Beechcraft SERVICE LETTER

Model: 23

No. 3

SEAT LOCK MODIFICATION ON THE MUSKETEER

FRONT VIEW - LEFT FRONT LEG OF SEAT.

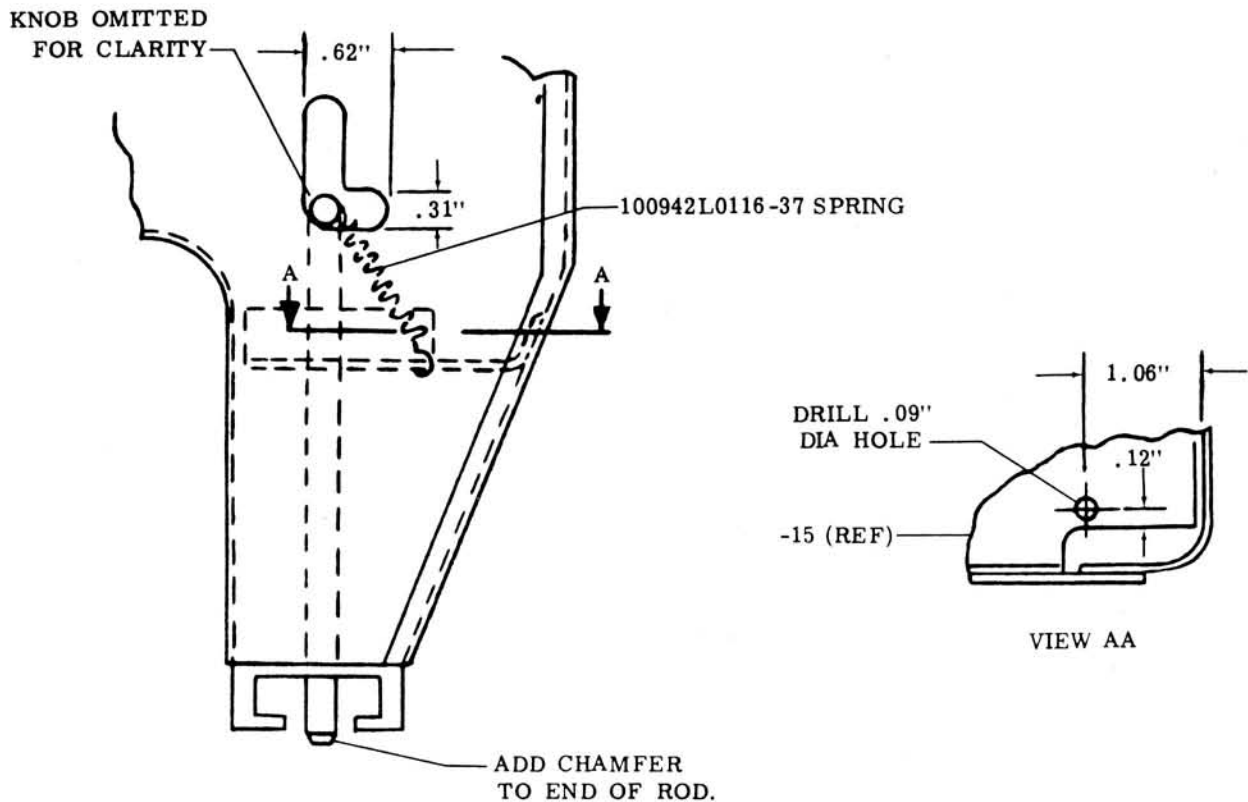
To insure more positive locking action of the front seats on the Model 23 Musketeer, the seat locking mechanism has been modified on aircraft M-192 and after. If seat locking difficulty is experienced on aircraft prior to M-192 the following modification may be made:

d. Rework the front of the seat frame, enlarging the hole as shown in the illustration.

e. Drill an .09 inch diameter hole in the 169-534012-15 bracket as shown in the illustration.

f. Replace the seat adjustment rod and attach a heavier spring, P/N 100942L0116-37, between the adjustment rod and the hole drilled through the bracket.

- Remove the front seats from the airplane.
- Remove the spring from the seat adjusting rod and remove the rod from the seat frame.
- Chamfer the end of the adjusting rod.
